**For 3no. Detached Dwellings, Tenterfield Drive,
Haddington**

From: Cheyne, Sarah
Sent: 02 March 2016 13:35
To: Slater, Kirsty
Cc: Environment Reception
Subject: RE: 15/00835/P 3 Houses at Tenterfield Drive, Haddington

To: Development Management
Per: Kirsty Slater
Ref: 15/00835/P

Subject: Erection of 3 houses and associated works

DRAWING TITLE: Tree Survey as existing
DRAWING No: KRA-TD-TS-01

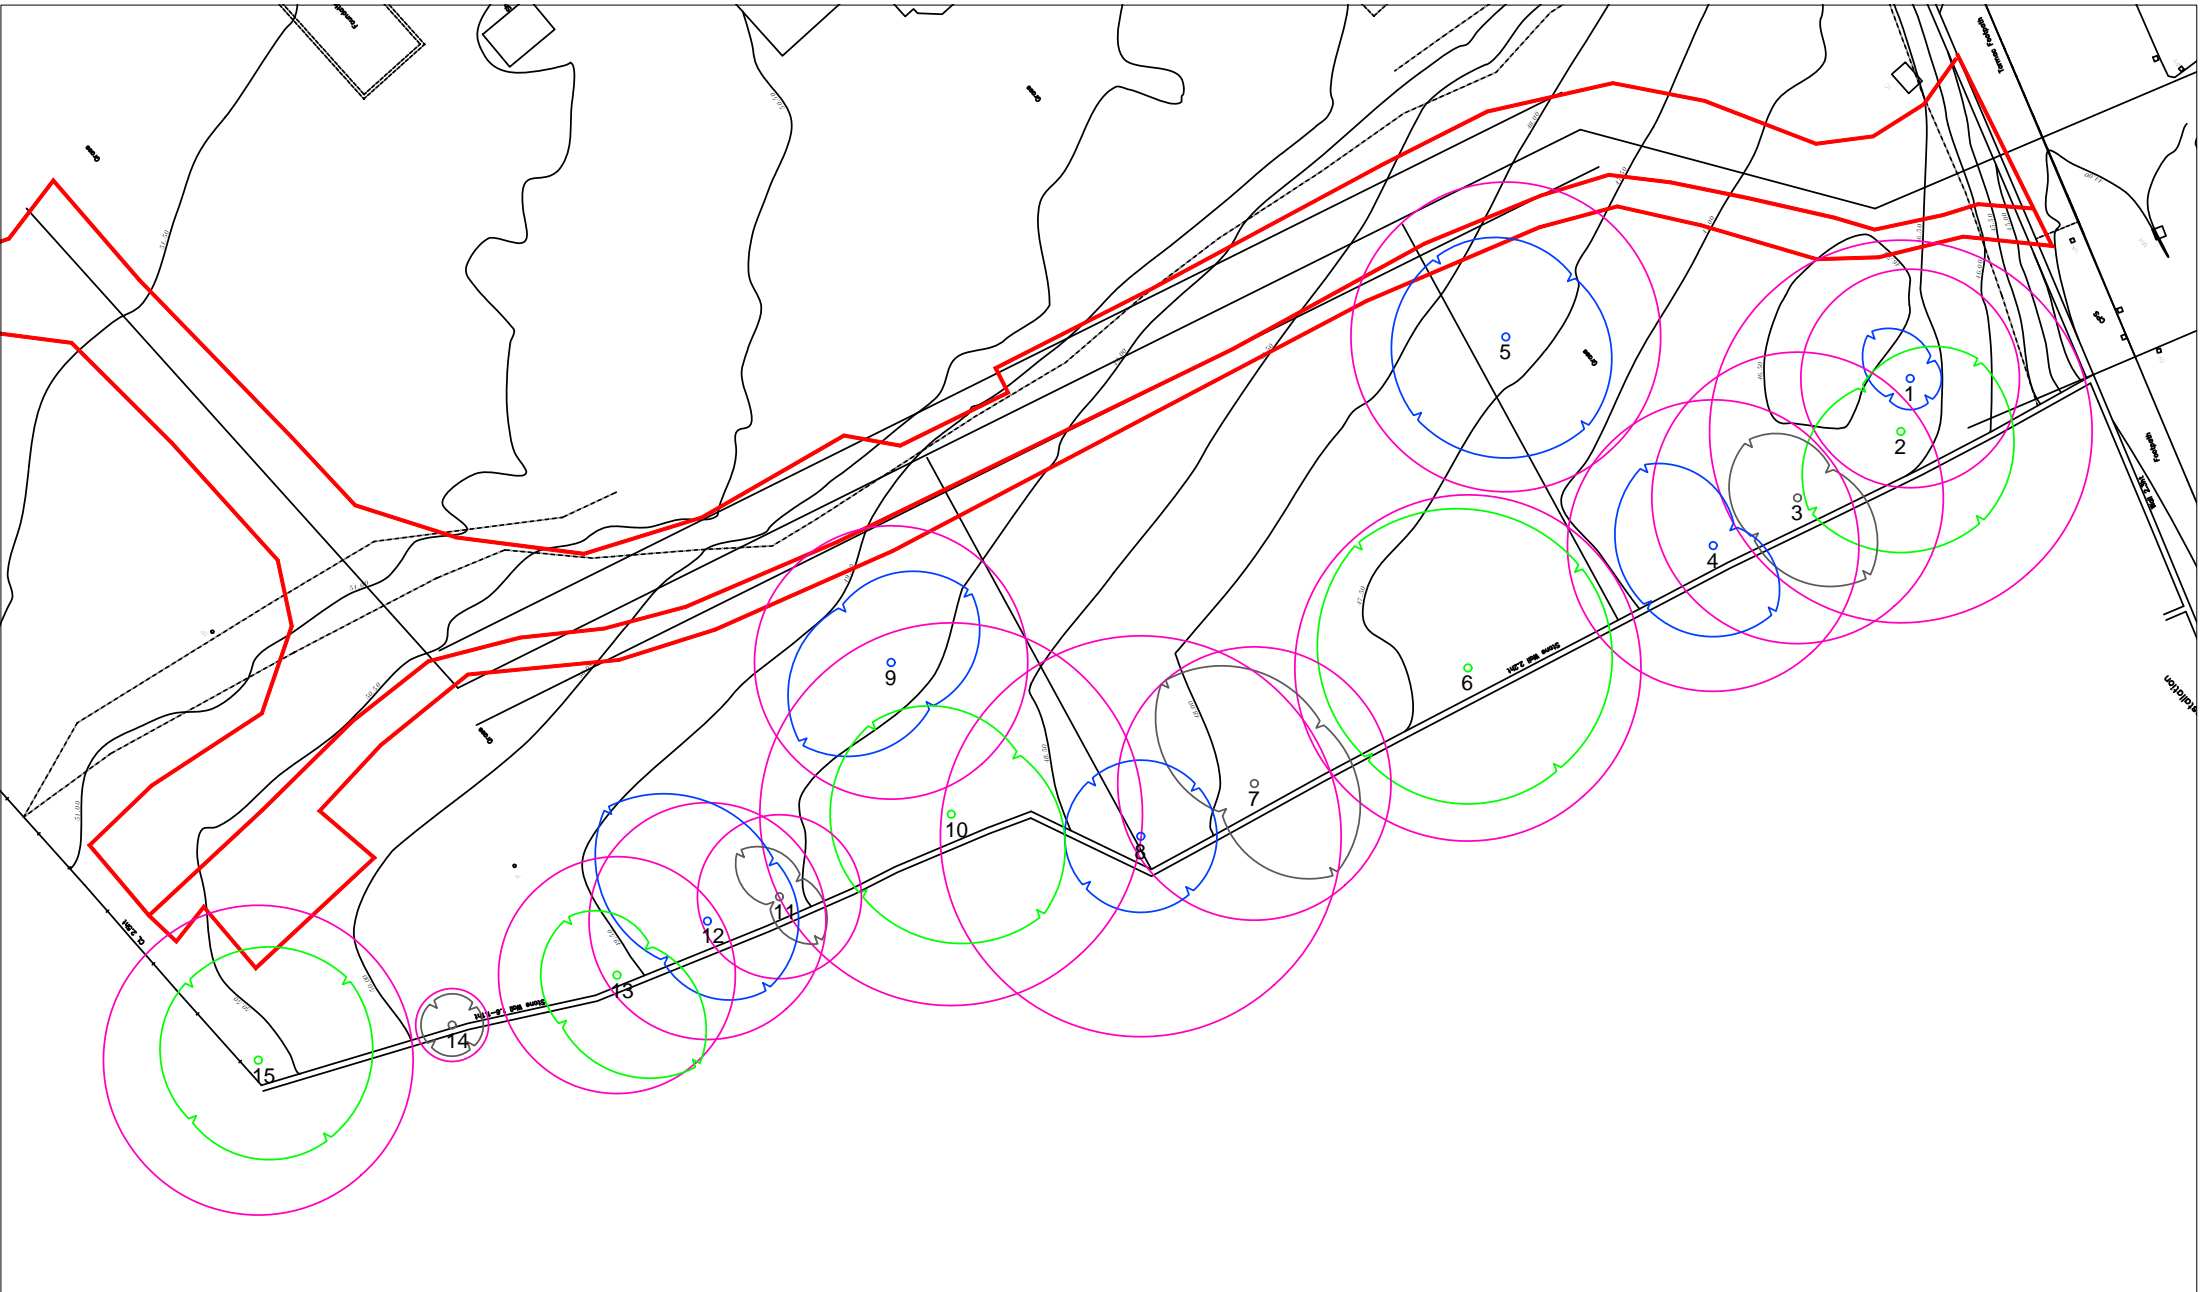
A Tree Survey and Arboricultural Constraints report has been carried out by Alan Motion Tree Consulting Ltd dated 1 February 2016. The tree survey identifies that while the site is more or less level, rising slightly from east to west, the level drops approximately 1.5m to adjacent garden ground with the boundary defined by a stone retaining wall. No assessment of the effect the wall and level change will have on the spread of the trees' roots has been included within the report and the root protection areas (RPA) have been drawn as circles around the centres of the trees.

Section 4.6.2 of BS5837:2012 'Trees in relation to design, demolition and construction' states that 'the RPA for each tree should initially be plotted as a circle centred on the base of the stem', but also that 'where pre-existing site conditions or other factors indicate that rooting has occurred asymmetrically, a polygon of equivalent area should be produced. Modifications to the shape of the RPA should reflect a soundly based arboricultural assessment of likely root distribution'. Clause 4.6.3 notes that any deviation in the RPA from the original circular plot should take account of factors including the morphology and disposition of the roots, when influenced by past or existing site conditions such as structures. The presence of the retaining wall and lower ground level to the south would suggest that root development will be limited to the south and therefore the tree roots and the corresponding need for protection are likely to extend much further within the site.

The Tree Survey and Arboricultural Constraints report identifies that the proposed houses cannot be constructed without incursion into the RPAs (based on a circle centred around the tree which we question the accuracy of) of the protected trees. As previously stated in my email of 23 December 2015 given the visual importance and sensitivity of these large mature trees protected by a tree preservation order we would not accept any incursion into any tree's RPA for any construction including underground services or pathways.

Any houses proposed here should be wholly outwith the trees' RPAs and allow for working space outwith the RPAs as well. The arboricultural assessment notes that no change in levels should take place within the RPA of the trees, yet no information on levels has been provided to show that this is the case here. The arboricultural assessment shows incursion into the RPA by the houses and the construction area. No assessment has been made for external access paths, drainage runs and other ancillary development. The arboricultural assessment clearly shows the developable area of the site outwith the RPA shown in magenta on the drawing titled "Tree Survey as existing" with drawing number KRA-TD-TS-01 and yet this has not been adhered to in the positioning of the development.

The presence of the retaining wall will undoubtedly have an impact on the tree root architecture. The trees have all grown in-situ adjacent to the wall for their entire existence. However, the suggestion that this means that roots will have extended away from the wall in the opposite direction, increasing the need for root protection to the north, is not credible. Tree roots grow through extension from the root tip as hair-like structures. In the case here, where they encounter a solid wall, they will divert and grow parallel to the wall. There is nothing in the site conditions to suggest that the specified Construction Exclusion Zone does not provide sufficient rooting volume to allow the successful retention of the trees. It is simplistic and misleading to suggest that because roots are restricted in one direction that they are likely to increase their spread in the opposite direction. The definition of the Root Protection Area is set out in BS5837 as a "layout design tool indicating the minimum area around a tree deemed to contain sufficient roots and rooting volume to maintain the tree's viability, and where the protection of the roots and soil structure is treated as a priority." There is nothing in that definition that states that it is a minimum distance from a tree. It is a measure of soil volume, based on a simple formula that takes absolutely no account of tree species, crown volume, health, vigour, soil type, or any other number of factors that influence overall tree growth and vitality. As a consequence, it is wholly inappropriate to quote the RPA as a *definitive* and absolute measure as is being done here. It is, as stated, a design tool.

The response states that houses should be positioned "wholly outside the trees' RPA". Yet Section 7 of BS5837 provides guidance on the precautions that need to be taken when working within the RPA. In other words, construction that encroaches within the RPA is acceptable providing precautions are taken. I have set out the required precautions in the method statement. Whilst the response selectively quotes part of Section 7.2 and uses this as a justification for the objection, it does not go on to refer to the remainder of that section (*...However, limited manual excavation within the RPA might be acceptable, subject to justification...*). If ELC wish to refer to BS5837:2012 as their main objection to the application, then it needs to refer to the document in its entirety, and not be selective about quoting it. BS5837 provides a significant amount of detail on how to manage works within the RPA, including sections on where it is acceptable to cut tree roots, so any suggestion that the miniscule incursion into the RPA by the current designs is going to result in the loss of trees or their terminal decline in completely without foundation.

DRAWING TITLE: Tree Protection Plan
DRAWING No: KRA-TD-TPP-01

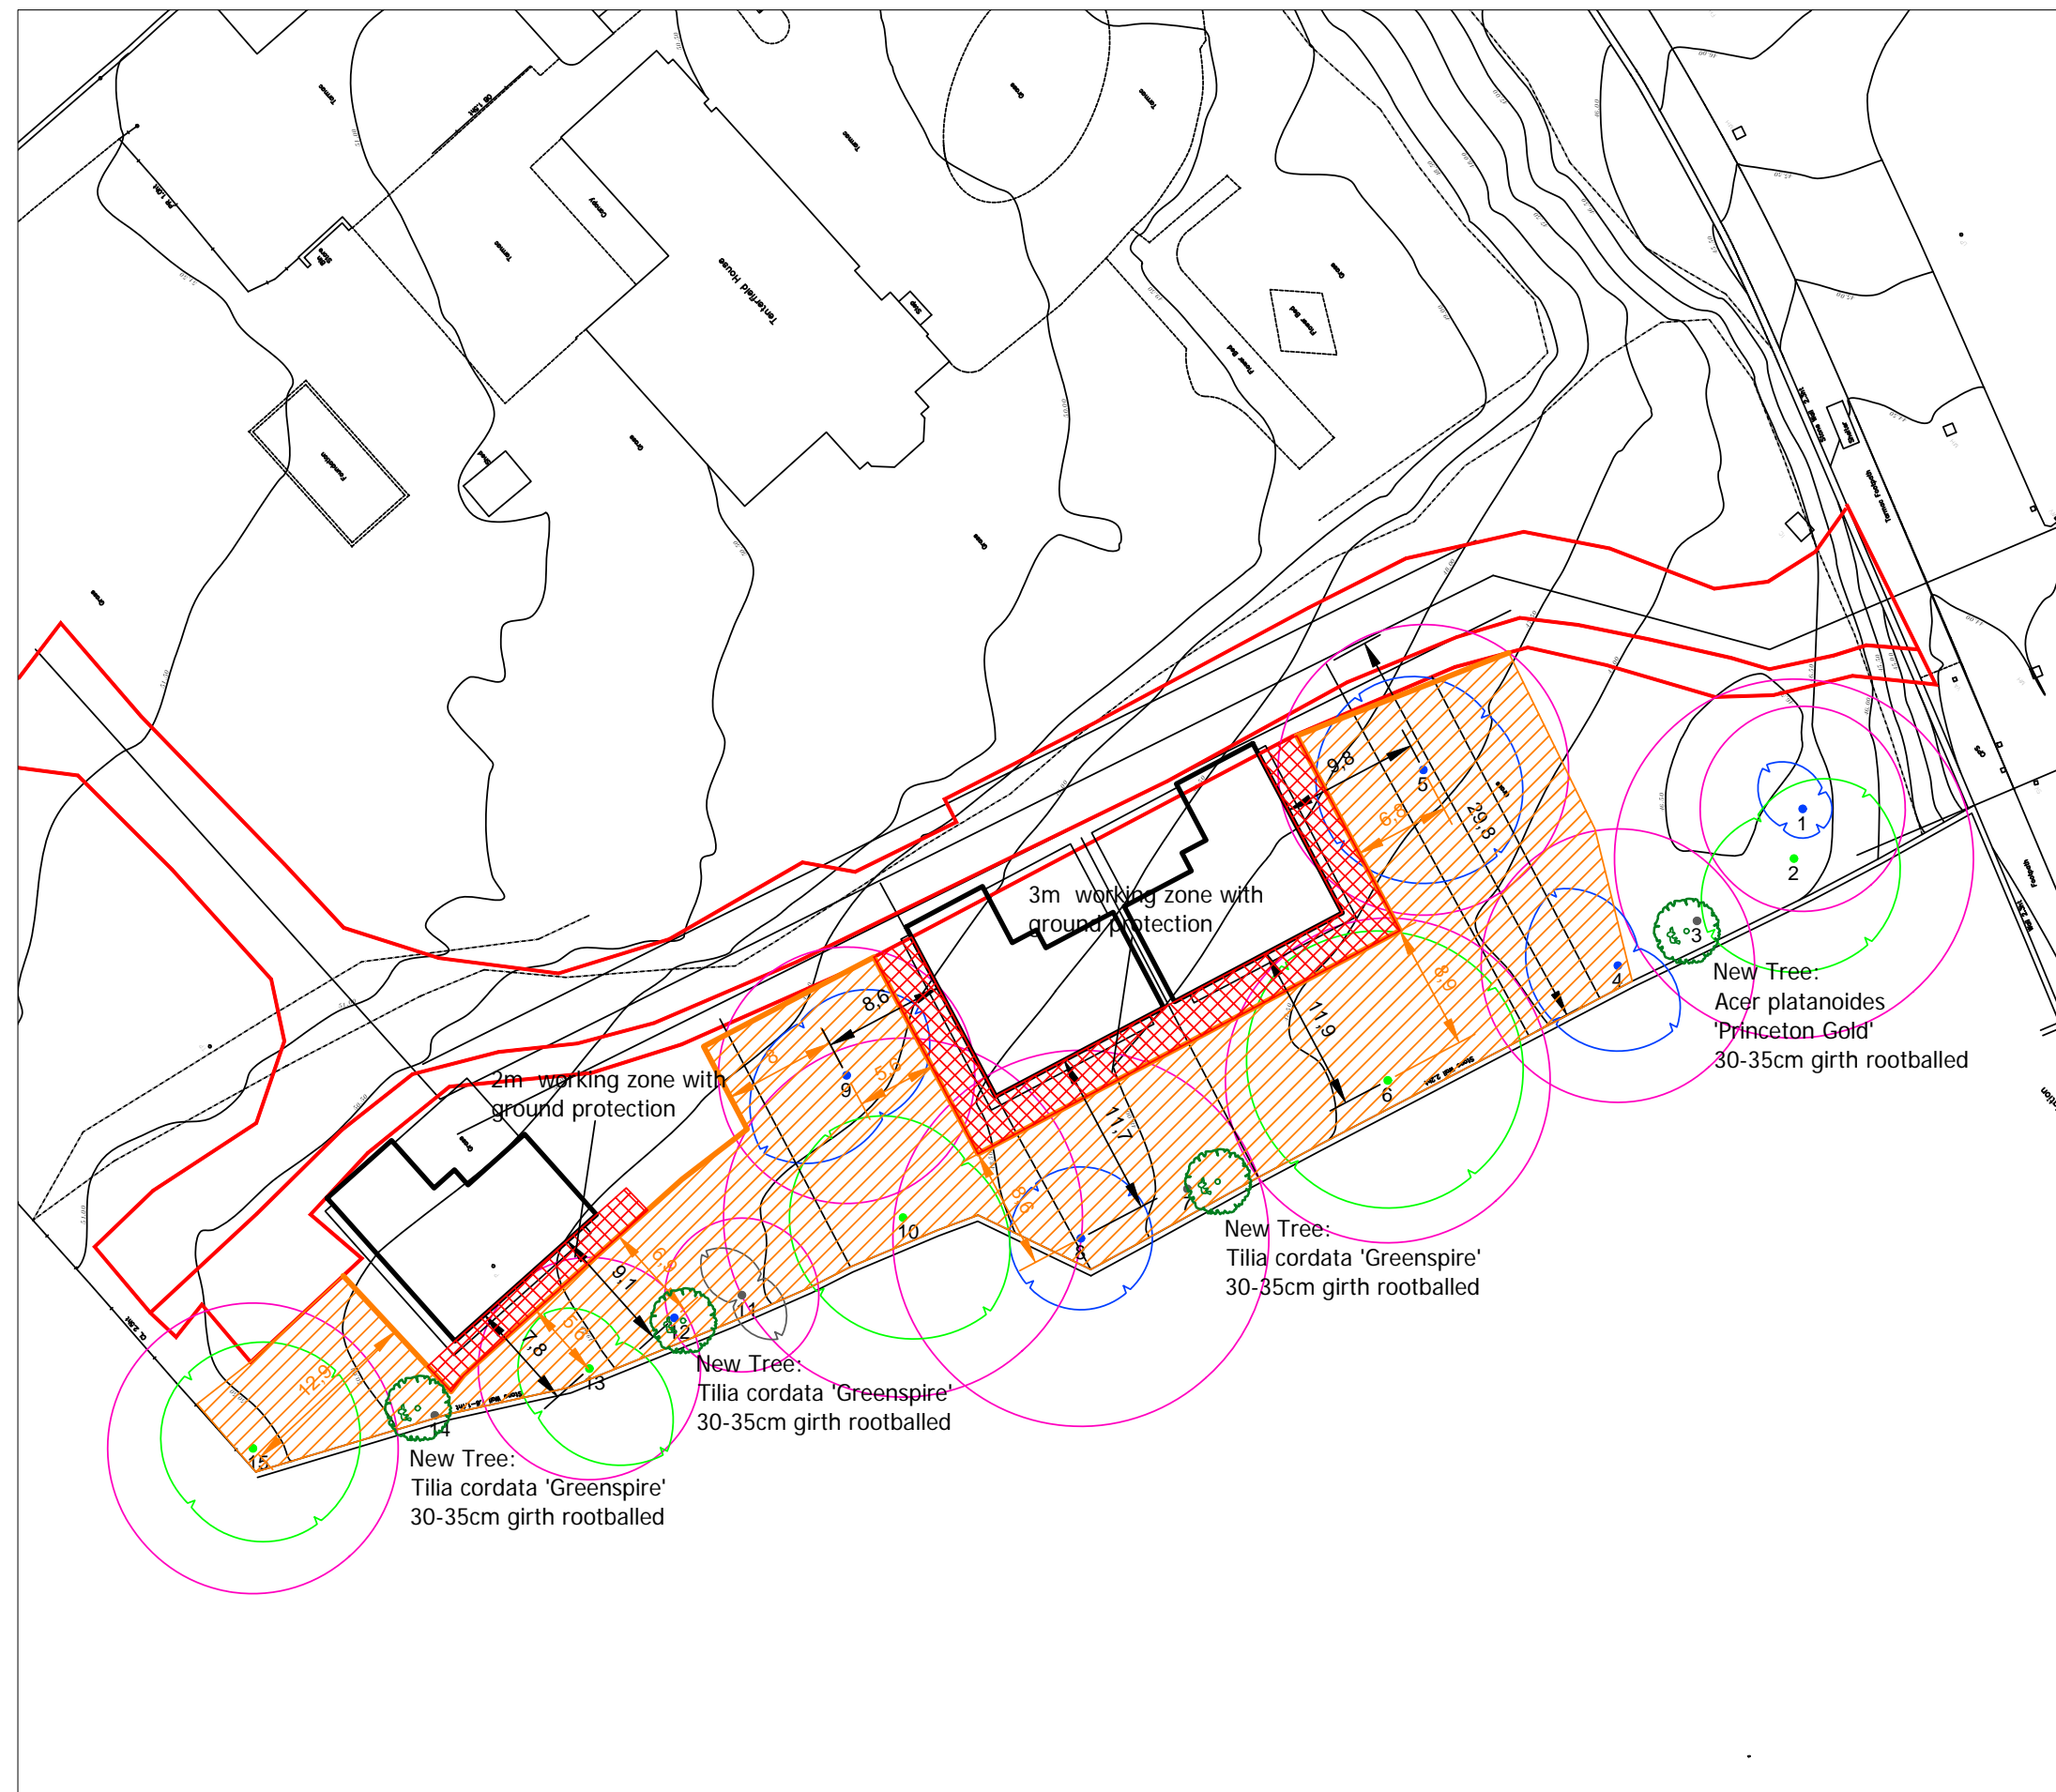
Paragraph 3 on page 7 states that there should be no excavations including service runs within the Construction Exclusion Zone yet then goes on to state that where service runs pass through the protected area these must be dug by hand. This appears to be a contradiction - if there are to be no excavations within the construction exclusion zone then this precludes the requirement for hand digging.

Additional works have been proposed within the RPA of the trees by the proposed rerouting of the culvert further south of its current location through the grass parkland from east to west. This furthers work within the RPA of the mature TPO trees. The arboriculturist has prepared a method statement for these works which requires excavation within the RPA by hand-held tools and refers to section 7.2 of BS5837:2012. It should be noted that the second sentence within section 7.2 states that "intrusion into soil (other than for piling) within the RPA is generally not acceptable, and topsoil within it should be retained in situ". This is the position we would stand by with regards to these significant trees and we would not support any works within the RPA.

It is also noted on the Site Plan for House 1 (dwg P(2-)002 rev. F) that the pavement is proposed to be realigned to provide a visitor parking space to the east of tree 5. This encroaches within the RPA of this

tree and has not been assessed within the tree report. The proposal now encroaches within the RPA of tree 5 to both the east and west side.

It is my professional opinion that the proposed development can be completed without detriment to the existing trees. This will require precautions, and will require the use of ground protection during construction as I have set out in the method statement. The proposed houses are no closer to the trees than the existing houses on the development are to retained trees within the gardens opposite. These retained trees remain in a healthy condition.
